**Letter to Board
1009 Beverly Drive**

January 8, 2020

Board of Directors
Parkfairfax Condominium
Alexandria, VA 22302

Picture of my White Arbor at former residence.

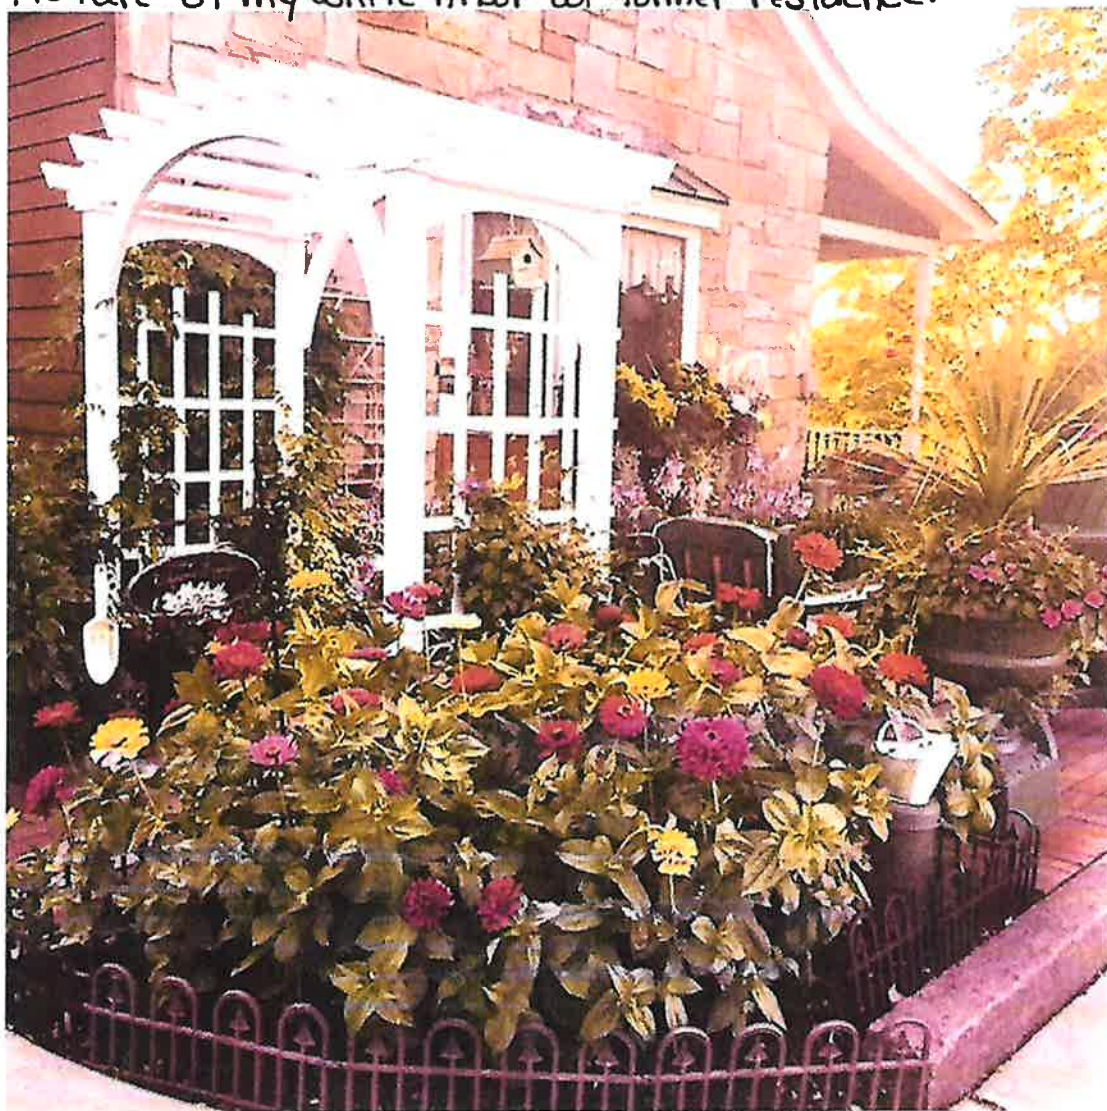
Whether we like a decision outcome or not, adherence to the process rules results in a legitimate ruling. While I have mixed feelings about the arbor's installation, primarily due to the

absence of VA811 markings, the arbor's placement (which appears to extend into the common area), and its oversized nature, I am actually more concerned about the Committee's noncompliance with approved process rules.
